AARON WILLIAM BEAN, INC.
GENERAL BUILDING CONTRACTOR

RE: 16717 Chirco Drive
Minor Residential Application MR-24-018
APN 424-20-014

RE: 16717 Chirco Drive
Minor Residential Application MR-24-018 – REVISED / RESUBMITTED
APN 424-20-014

Circular driveways like this are discouraged

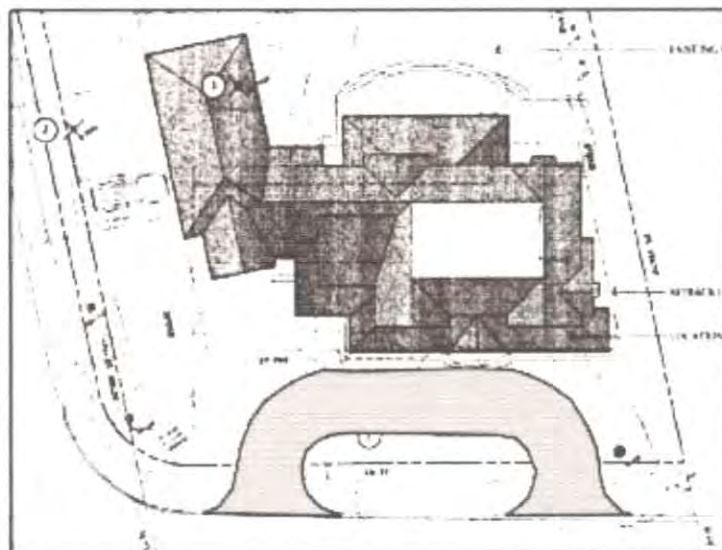
Mr. Cannon also points out that the “circular driveway” is “not consistent with Residential Design Guideline 2.4.4”. I would argue that the “circular driveway” as designed is not really a circular driveway at all. It is simply a good design to access both garage entrances, while allowing a vehicle to turn around when backing out of the garage as to approach Chirco Drive in a front facing manner. Chirco is a busy, throughfare street, which means backing out is difficult and unsafe. It should be noted that a circular drive by architectural definition typically crosses a majority of the front of a property, in front of the main entrance of the home, providing significant off-street parking for guests and visitors – not just garage access (specifically see the diagram in the Residential Design Guidelines adjacent to 2.4.4).
